Landscape Rationale- Additional Information

Construction of 11no. Residential Units at;
Main Street,
Rathcoole,
Co. Dublin

SD22A/0323

6. Public Realm - Play Areas.

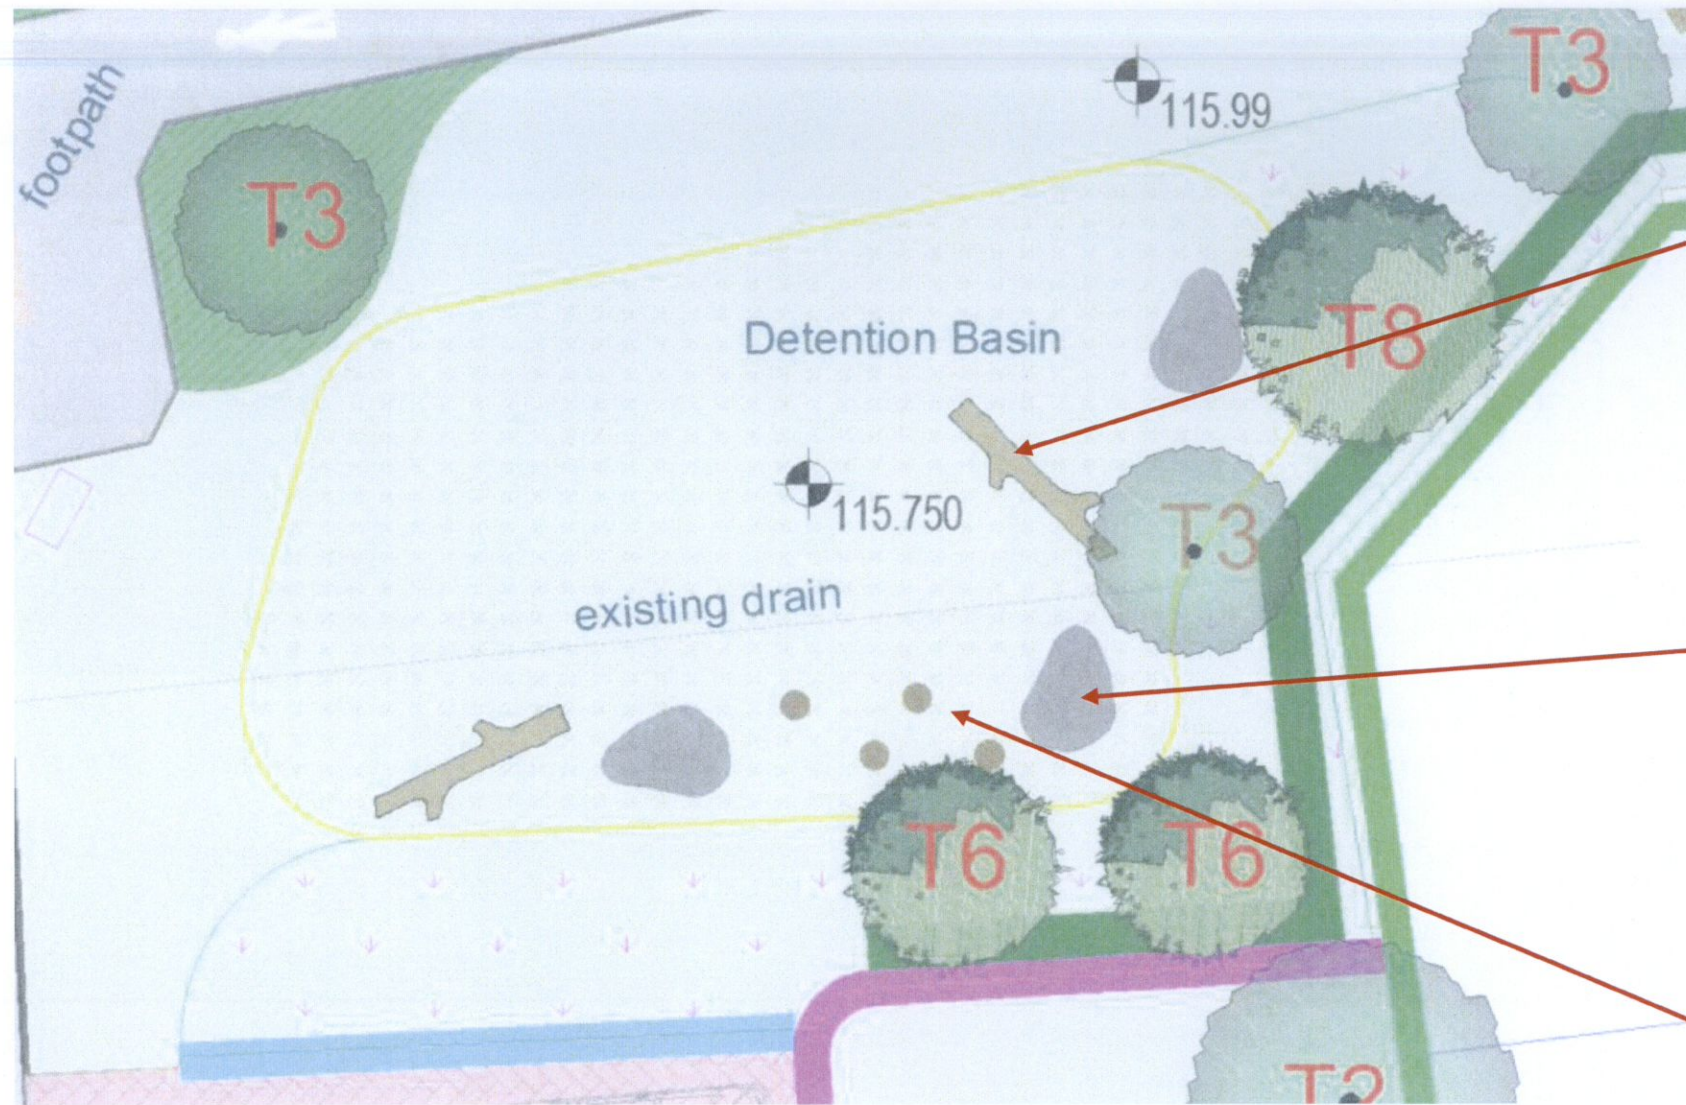
The applicant is requested to submit a detailed Play Rationale and Layout Plan (separate to, but related to the Landscape Masterplan), using natural and nature-based solutions, to provide informal, impromptu and spontaneous play opportunities, along with play equipment that provides appropriate challenges for multiple age groups. The Layout Plan shall comprise the following: -

- showing types of play and play area(s),
- target age groups,
- landform (included levels and contours) and boundaries,
- design and construction details of play opportunities and facilities in respect of landform, planting, boundaries, equipment and safety surface. All play equipment and ancillaries shall conform to European Standards EN 1176-1-11 and EN 1177 Playground equipment and surfacing, and to BS/EN standards 2017/18 for Playground Installations for HIC (Head Injury Criterion) and CFH (Critical Fall Height). The applicant should show compliance with the following policy in the South Dublin County Development Plan 2022 – 2028:
 - Policy COS4 Objective 6;
 - Policy COS5 Objectives 19 to 28;
 - Section 12.6.10 guidance on Children's Play Areas (noting requirements for schemes of more than 10 units and predominantly 3+ bedroom units).

The play information will follow on the next pages and touch on the play items we propose. We have indicated the ages that items are safe for and then also have a spot level outside the detention basin. The items will be incorporated into the slopes of the detention basin which will be at $\frac{1}{4}$ or $\frac{1}{5}$ (to be agreed with SDCC).

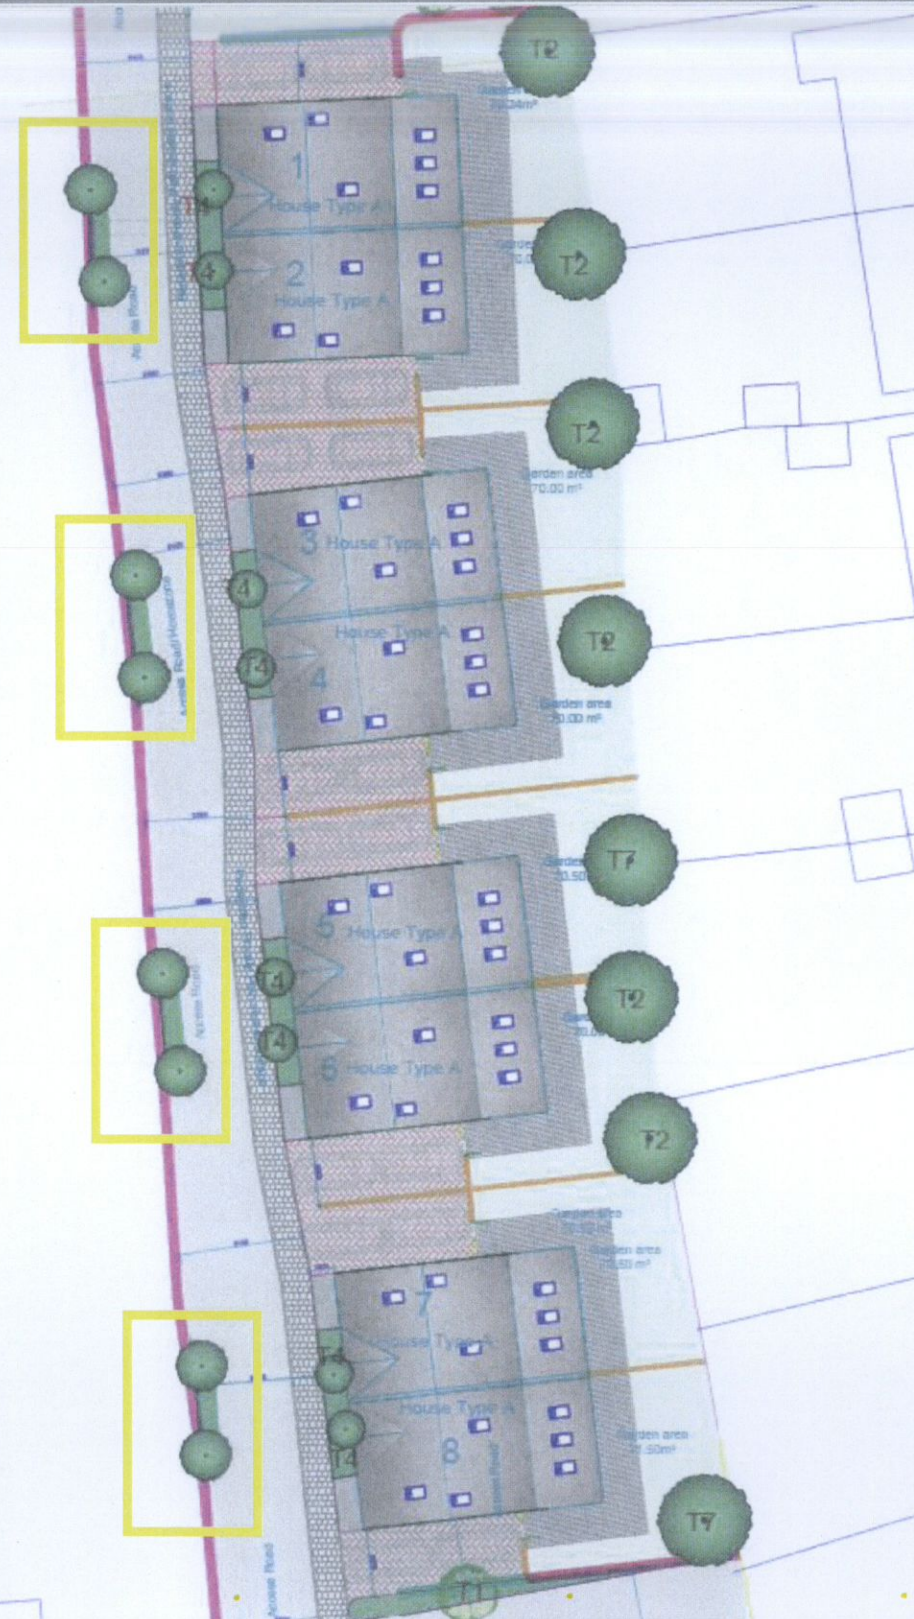
- (a) The applicant has not provided details as to the levels and gradients within the proposed public open space areas. The developer is requested to submit level details for the open space areas, this shall include cross section drawings where applicable.

- (b) As required under the current County Development Plan; Development should seek to maximise the use of permeable surfaces, as well as opportunities for stormwater attenuation and storage through SuDS and limit the use of underground attenuation and storage. In addition, SuDS measures will only be accepted as an element of public open space where they are natural in form and integrate well into the open space landscape supporting a wider amenity and biodiversity value.

- (c) There is a lack of street tree planting. The applicant is requested to provide a standalone plan that clearly identifies street trees to be planted within the Public Realm and those that contain SuDS Features. On-street car parking to the north of the development shall be combined with regular tree planting and a high standard of kerbing and paving. It is a general objective that not more than five perpendicular or two parallel car parking spaces be allowed between trees. Trees shall be planted into a porous material with structural root soil and constructed tree pits between the car spaces. Tree pits shall contain SUDS features.

The site has been redesigned and has been looked at from a SuDs perspective, and how it can be utilised as much as possible. Permeable paving has been added in as many locations as possible, tree pits are going to be installed along the roadside and there will be a detention basin in the open space.

Regarding the street trees, the roads engineer on the project felt that for reversing out onto the road from housing that the trees in the street would cause issues. Therefore they have been left out and we instead have trees out the front of the houses with tree pits.

We will attach an image of our design with the trees in the street and we are happy to liaise with the council to find the most appropriate solution.

9. Green Infrastructure.

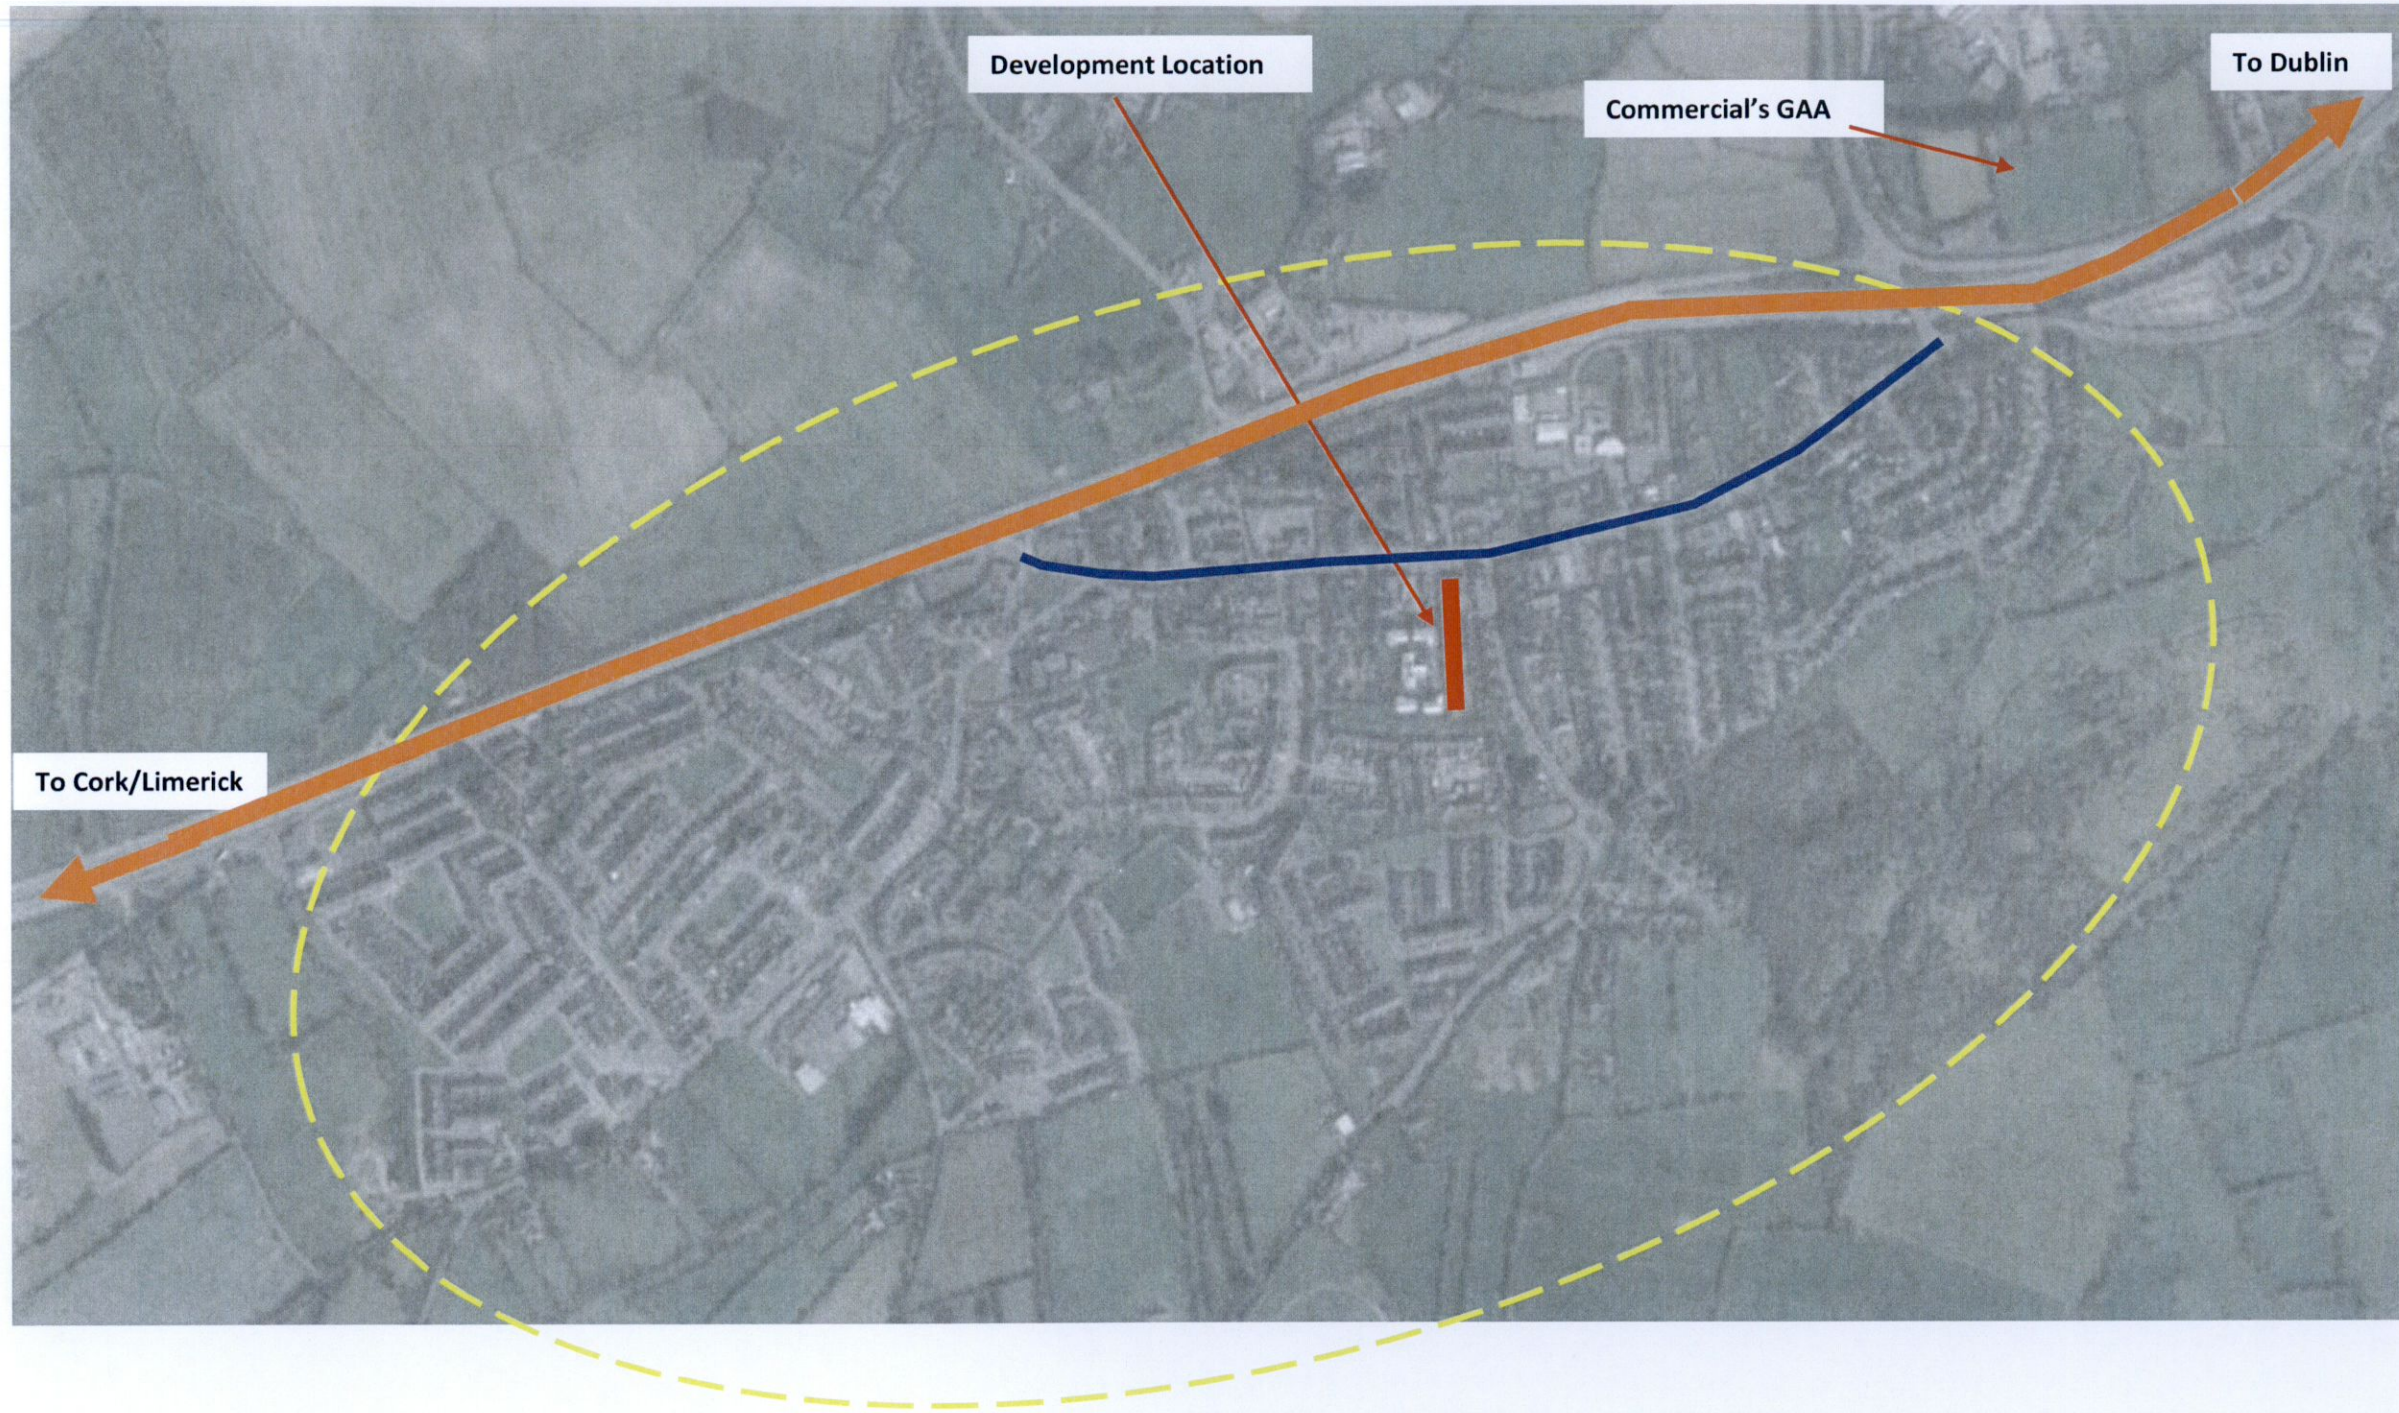
- (B) In compliance with section 12.4.2 of the County Development Plan, the applicant is requested to submit a Green Infrastructure Plan which should include the following:
 - - Site location plan showing the development site in the context of the wider GI as shown on the Council's GI Plan for the County;
 - - Site survey and analysis, identifying existing GI Infrastructure and key assets within the site;
 - - Indicate how the development proposals link to and enhance the wider GI Network of the County;
 - - Proposed GI protection, enhancement and restoration proposals as part of the landscape plan, where appropriate, for the site;
 - - Proposals for identification and control of invasive species.
 - - an overall site summary quantifying and detailing the following: tree and hedgerow removal; tree and hedgerow retention; and new tree and hedgerow planting.

Please see GI plan rationale attached. This breaks down the green infrastructure on the site and how it interlinks with the outer context.

An invasive species survey will be carried out on site before construction.

There are no existing trees or hedges on the site.
